Addendum No. 1

Project Name: Merchant's Alley Archway Project	Project No.: 24-25-12
Prepared By: Michael Turner	Date: October 9, 2024

Attachment 1 – Site utilities along 5th street end of Merchant's Alley (For reference only)

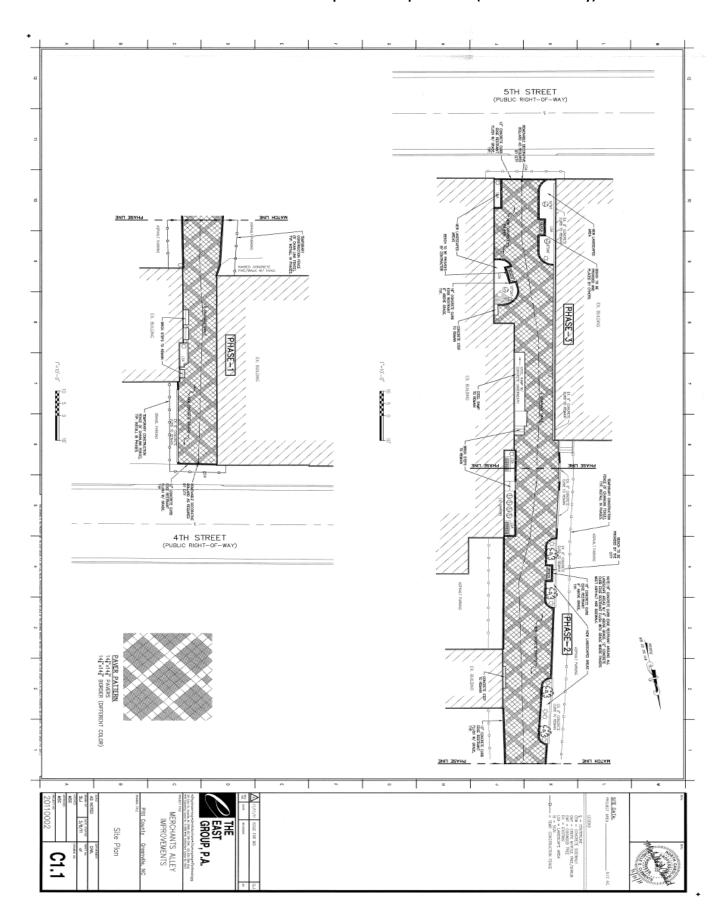
- 1. The engineered drawing call for the cabling to be galvanized and rated at 20,000 lbs. but the specs call for stainless. Which one is correct?
 - Answer: All cables (main and auxiliary) shall be stainless steel. Main cable shall be one-half (1/2) inch with a minimum breaking strength of 20,000 lbs.
- 2. Can the City do locate for the column footers? They are 6'-0" deep. Do we know that we are clear from any underground utilities?
 - Answer: The contractor will be responsible for locating all underground utilities utilizing North Carolina 811 and Greenville Utilities Commission (GUC), as well as coordinating the relocation of utilities if necessary. Hand digging will be necessary in instances where an auger bore could compromise underground utilities.
- 3. Can we have an allowance for relocating site utilities?

Answer: Yes. The allowance will be in the amount of \$15,000.
